Subject: Zoning Ordinance Amendment, to revise the PUD-16 Zoning District to include a new Overall Development Plan and Site Plan Review for 7200 and 7250 France Avenue

RE: 7200 – 7250 France Ave – Development Review

7200-7250 France Site Plan: Staff Comments on Transportation Elements

Turning Performance Analysis

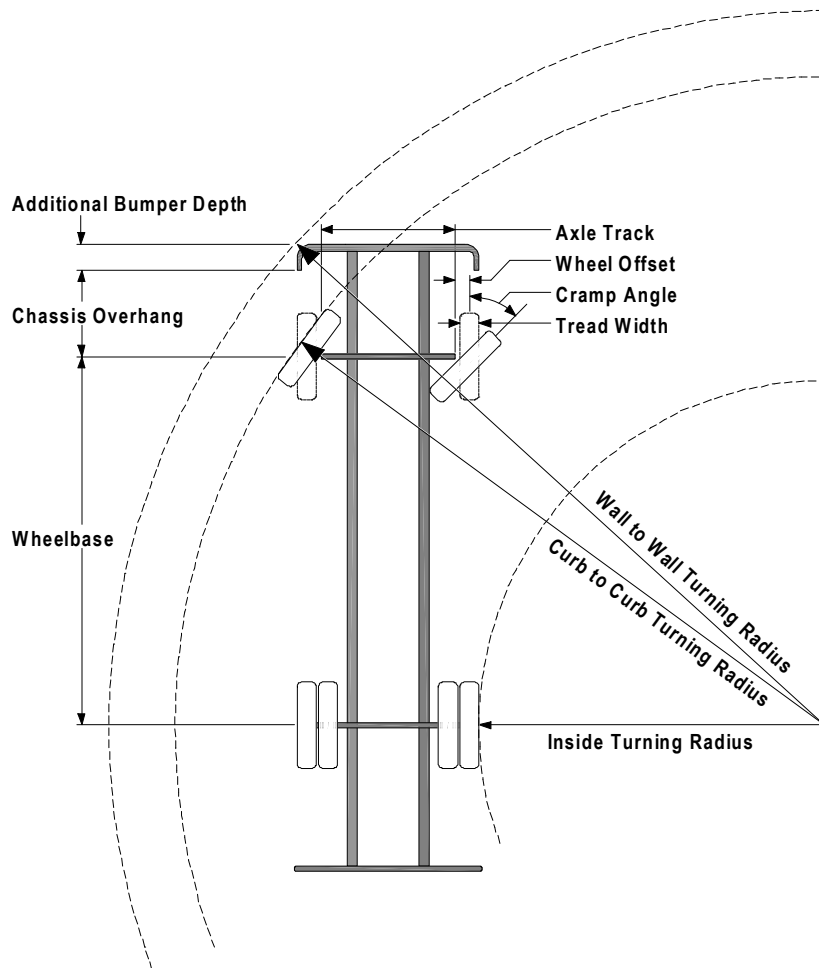
12.	Review fire access requirements with fire department. Fire truck turning template attached.	Grading/Building Permit
13.	Provide traffic study and implement City-approved recommendations.	Grading/Building Permit
14.	Driveway entrance permit required for entrance reconstruction. Add pedestrian ramps. Comply with standard plates 410 and 415.	Building Permit
15.	Road patching shall conform to Edina standard plates 540 and 543 on Gallagher Dr and 540 and 545 on 72 nd St W. Comply with County requirements for France Ave S.	Certificate of Occupancy
16.	Proposed France Avenue lighting must remain consistent with Canto light fixtures and be the responsibility of the property owner.	Grading/Building Permit
